PR/1526/22

Record of Executive Business and Chief Executive's Order

Reg. Reference:SD22A/0382Application Date:06-Oct-2022Submission Type:New ApplicationRegistration Date:06-Oct-2022

Proposed Development: Construction of a) a metal clad single-storey

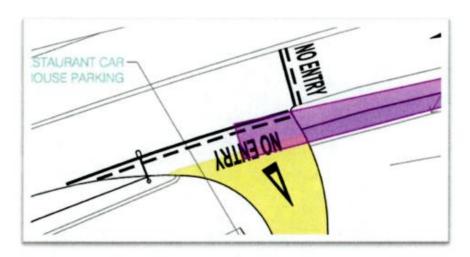
Roads comment: this proposed solution has not been included in the drawings.

PROBLEM

Although road markings are proposed at the egress point to demonstrate that the service road is one-way only there is a risk that in certain weather conditions and lighting that drivers may not realise this. This could result in wrong way driving and head-on collisions.
